**NEW YORK STATE THRUWAY AUTHORITY
DEPARTMENT OF ENGINEERING**

**AMENDMENT NO. 2
TO**

**CONTRACT TANY 26-23B
D215110
SUPERSTRUCTURE REPLACEMENT OF THE
GARDEN STATE PARKWAY CONNECTOR BRIDGE
OVER THE THRUWAY (I-87/I-287) AT MP 23.53
IN THE NEW YORK DIVISION
OF THE NEW YORK STATE THRUWAY
IN ROCKLAND COUNTY**

**IN THE LETTING OF
OCTOBER 7, 2026**

CONTRACT NUMBER:
TANY 26-23B
DATE:
JULY 2026
DRAWING NUMBER:
TYP-01

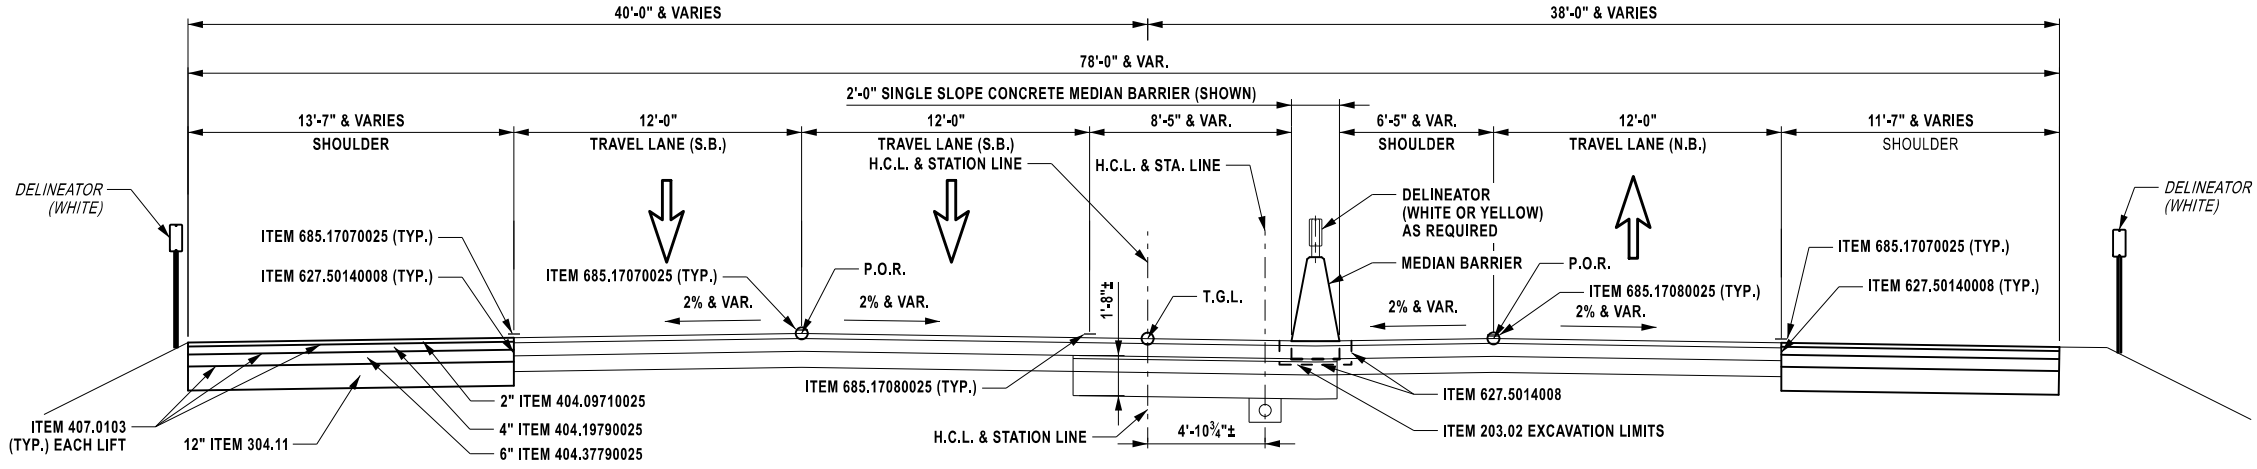
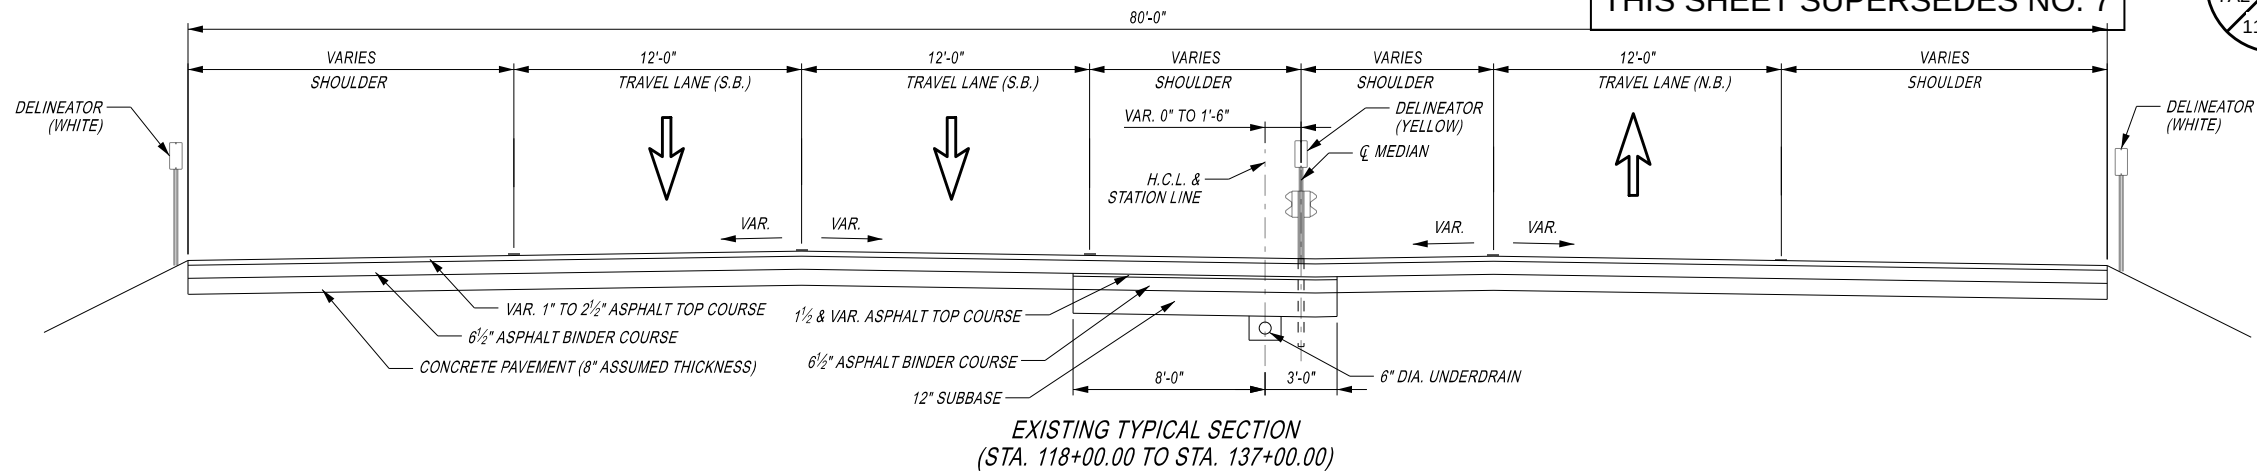
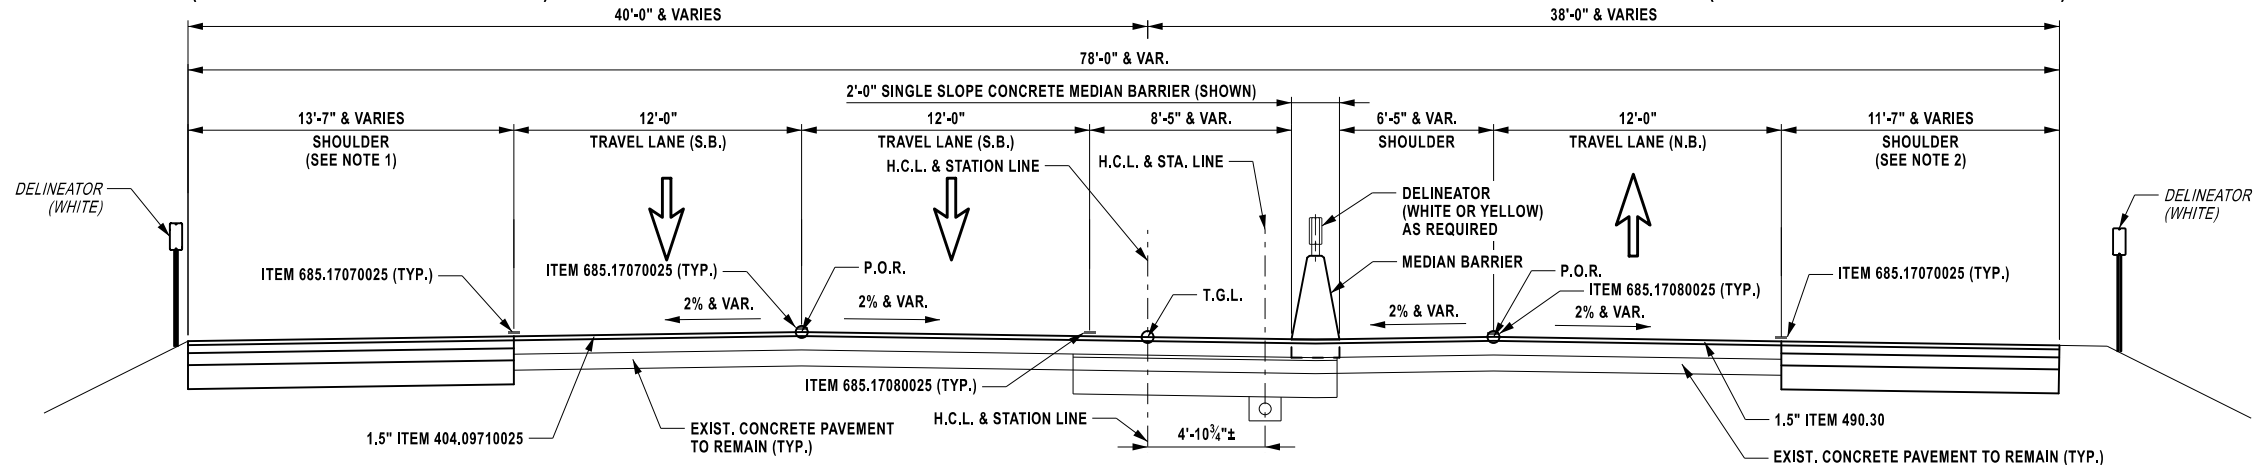
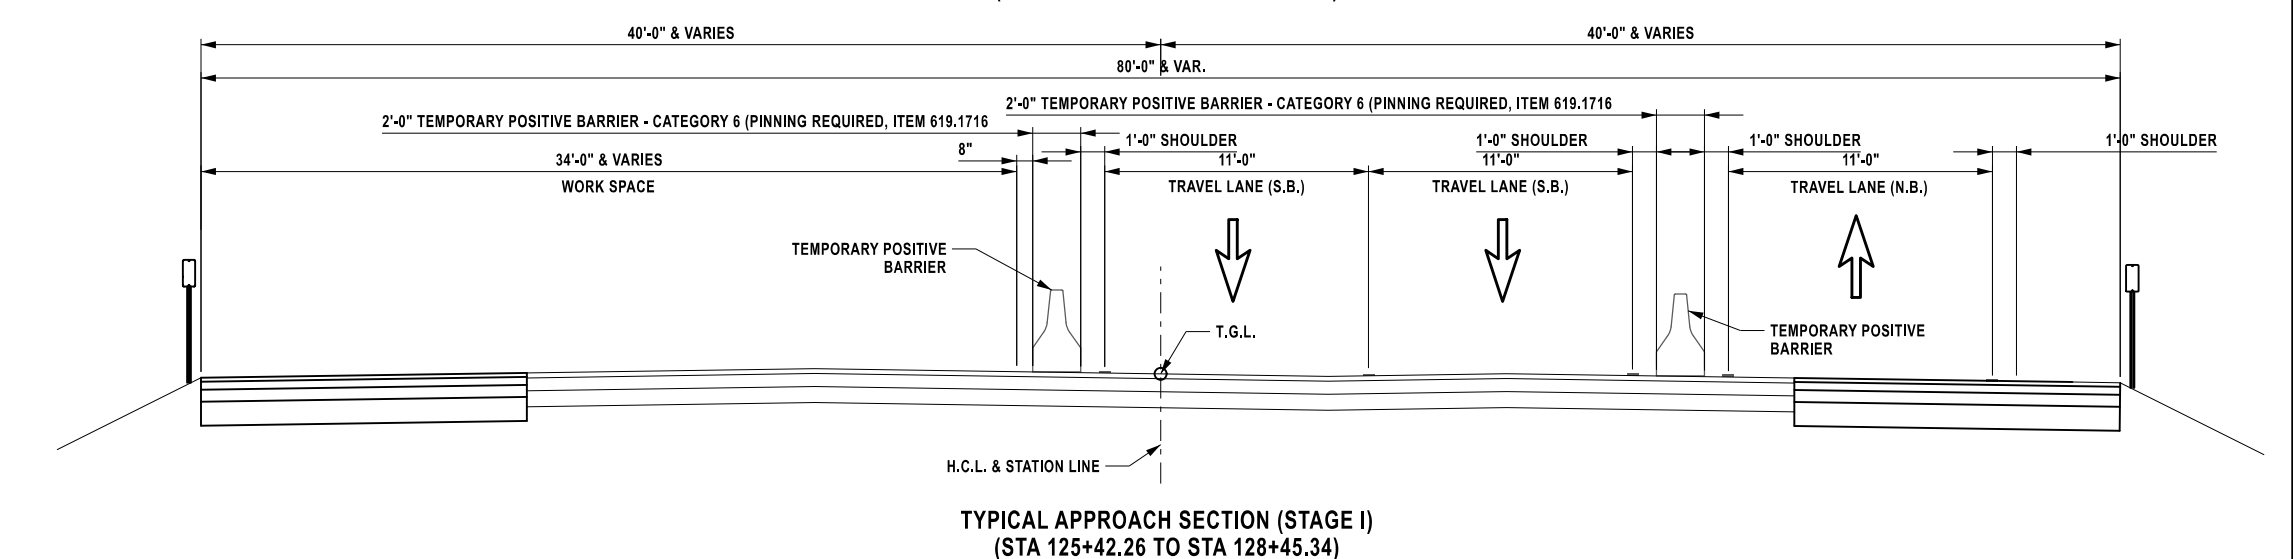
4. **DELETE** Drawing Number TYP-01, Sheet 7 of 118, and **SUBSTITUTE** with the attached Drawing Number TYP-01, Sheet 7A2 of 118. The Shoulder Replacement Station Limits of Work have been corrected to match the General Plans. Note 2 has also been updated.
5. **DELETE** Drawing Number TYP-02, Sheet 8 of 118, and **SUBSTITUTE** with the attached Drawing Number TYP-02, Sheet 8A2 of 118. The Shoulder Replacement Station Limits of Work have been corrected to match the General Plans. Notes 1 and 2 have also been updated.

AECOM	TITLE OF PROJECT SUPERSTRUCTURE REPLACEMENT GSP CONNECTOR OVER NYS THRUWAY	CONTRACT NUMBER: TANY 26-23B
	LOCATION OF PROJECT BIN 5514049 (MP 23.53)	DATE: SEPT 2026
	TITLE OF DRAWING STAGING SECTIONS (1 OF 3)	DRAWING NUMBER: ST-05

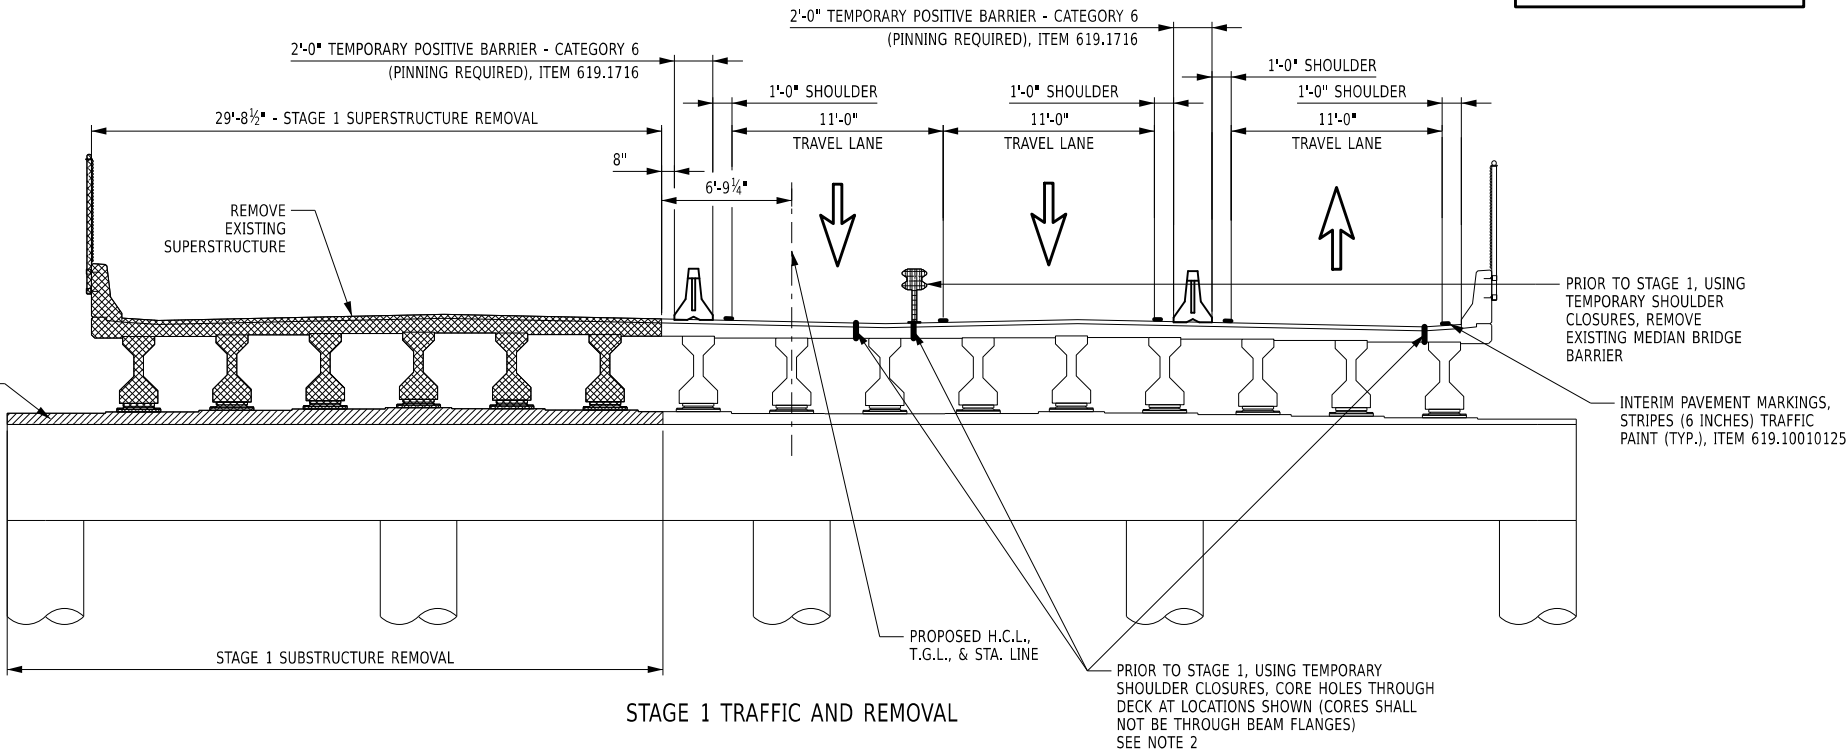
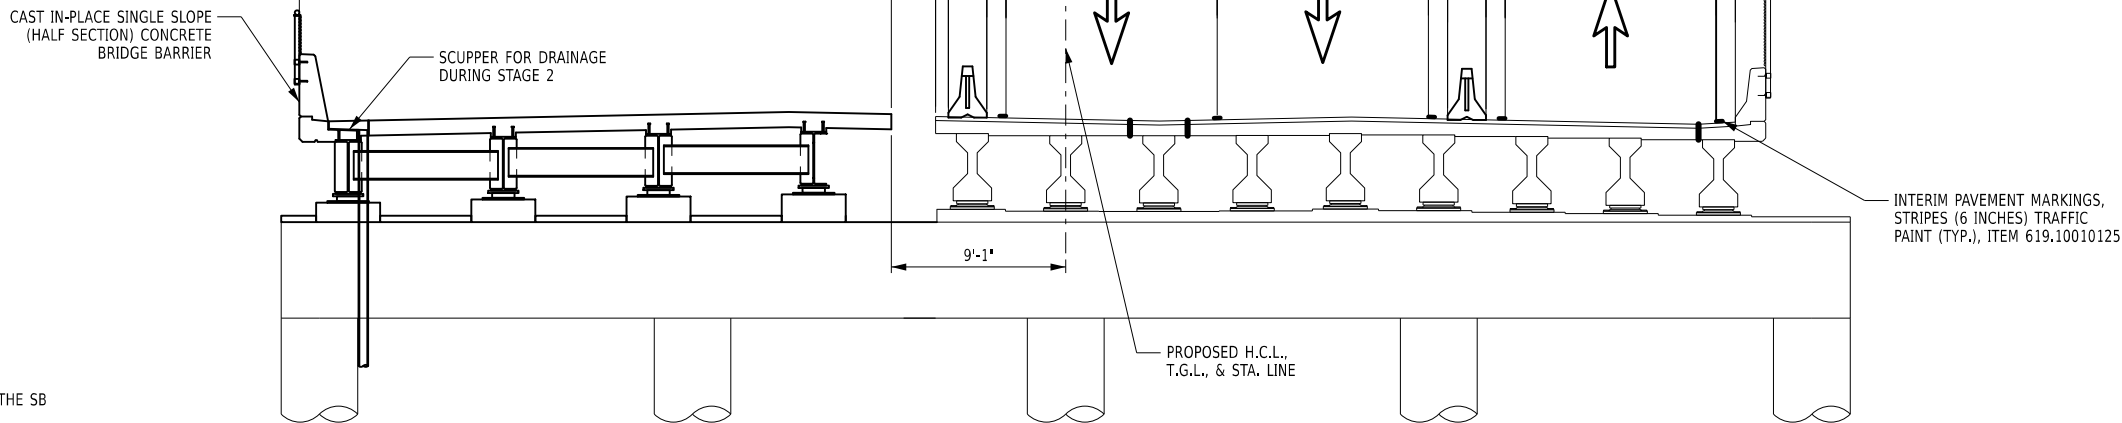
9. **DELETE** Drawing Number ST-05, Sheet 55 of 118, and **SUBSTITUTE** with the attached Drawing Number ST-05, Sheet 55A2 of 118. Post Tensioning Detail and Notes have been add on the upper lefthand side of the drawing.

TITLE OF PROJECT SUPERSTRUCTURE REPLACEMENT GSP CONNECTOR OVER NYS THRUWAY	CONTRACT NUMBER: TANY 26-23B
LOCATION OF PROJECT BIN 5514049 (MP 23.53)	DATE: JULY 2026
TITLE OF DRAWING PIER 1 REPAIR PLAN & ELEVATION (1 OF 2)	DRAWING NUMBER: ST-21

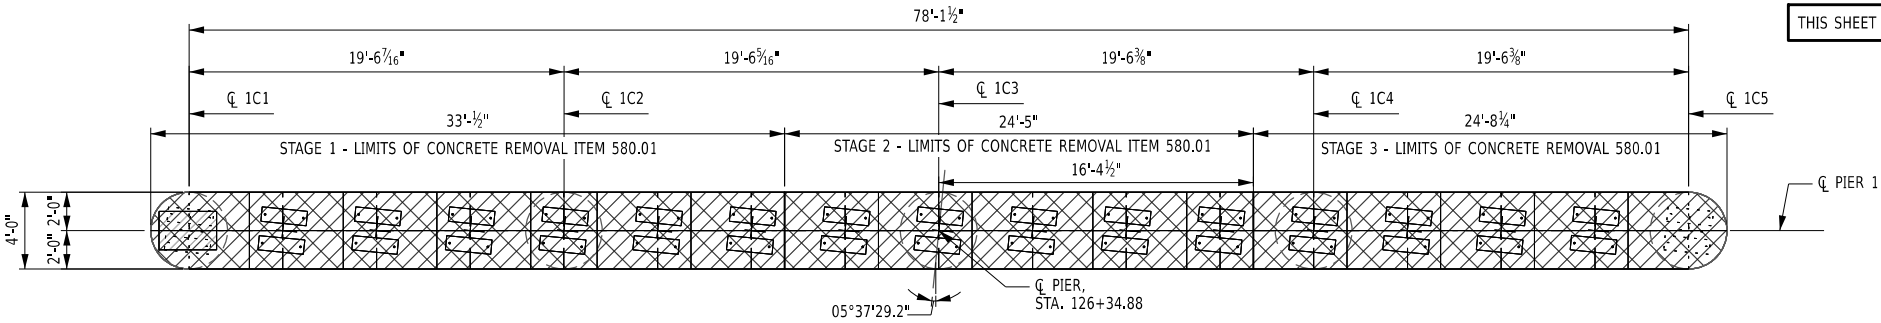
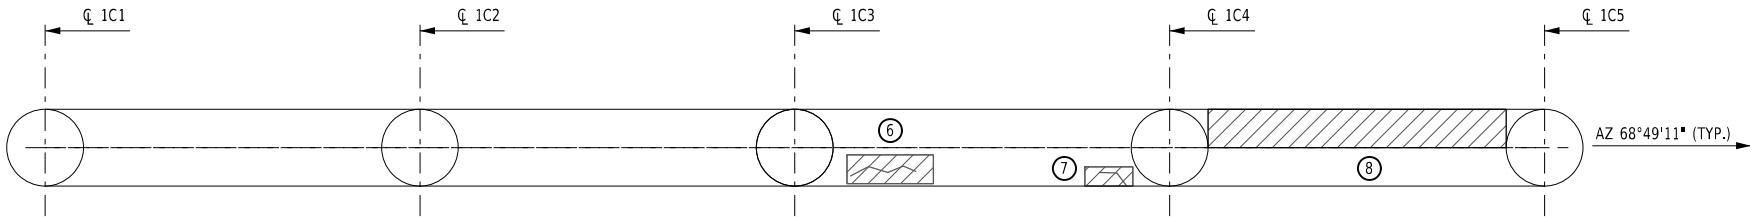
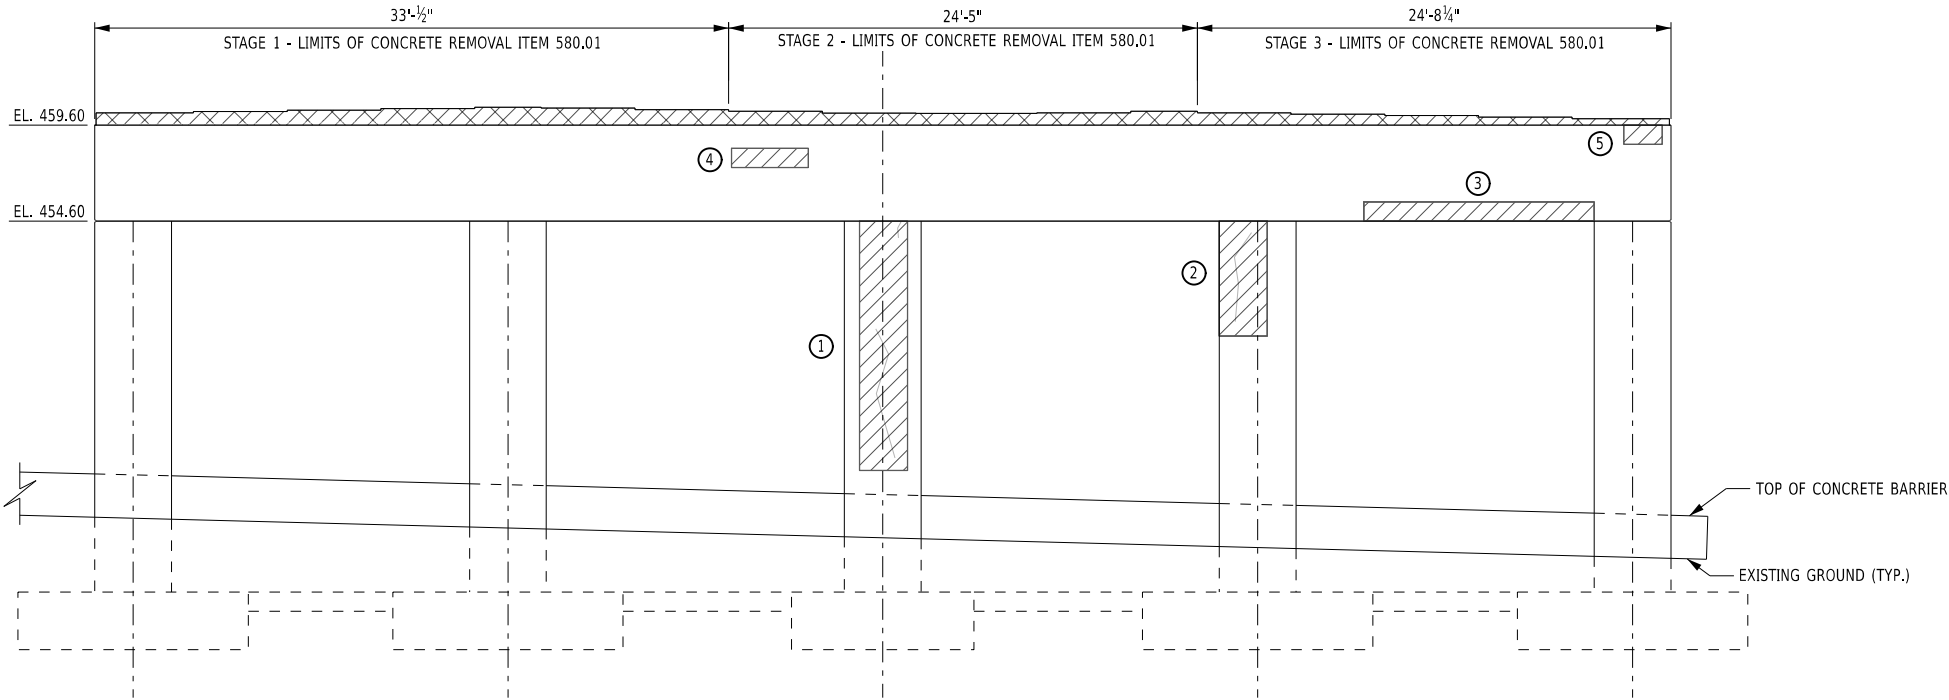
10. **DELETE** Drawing Number ST-21, Sheet 71 of 118, and **SUBSTITUTE** with the attached Drawing Number ST-21, Sheet 71A2 of 118. The estimated quantities for Item 580.01 have been updated in the Concrete Removal Table.
